HARWIN

Re: Product change notification for Harwin product.

There has been a change to the tape pocket and cover tape design on the following products:

Example of the new tape design - S7171-45R:

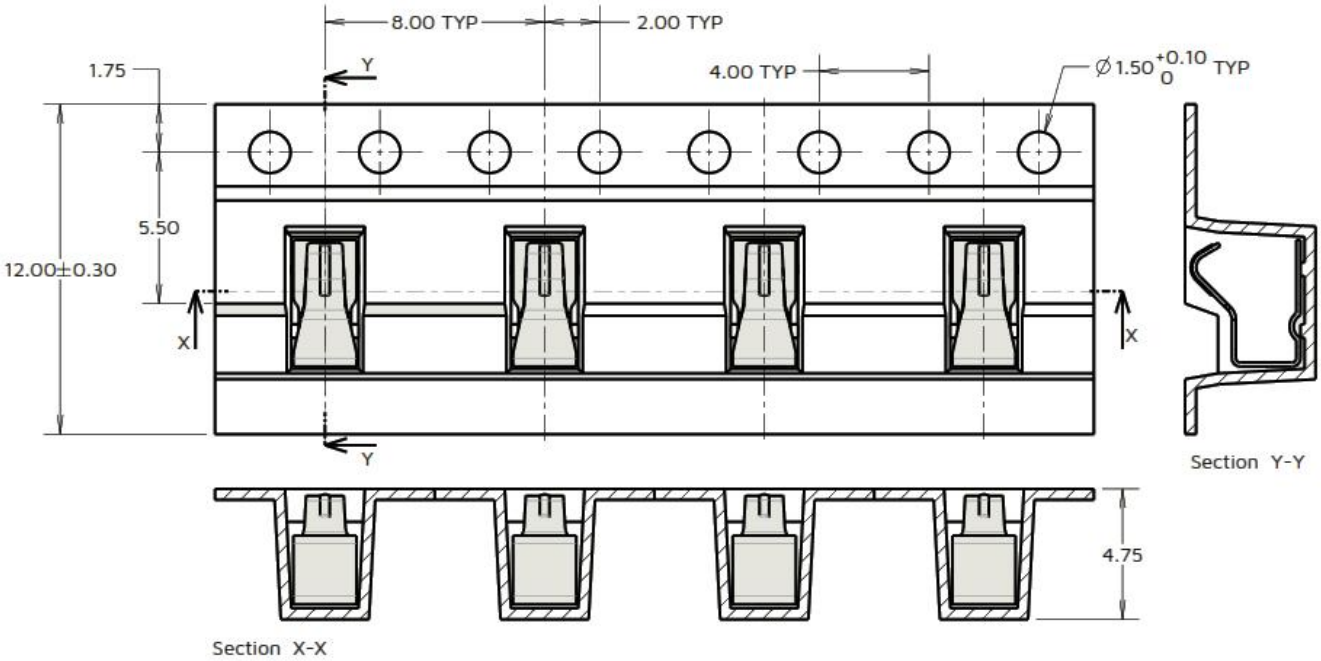
The tape pocket now has a channel running along the length of the tape, and the cover tape now dips down into this channel. This revised packaging method has been tested and continues to meet the EIA-481 requirements. The spring contact itself is not affected and remains unchanged.

This packaging improvement minimises the risk of these miniature low-profile contacts turning or twisting within the pocket.
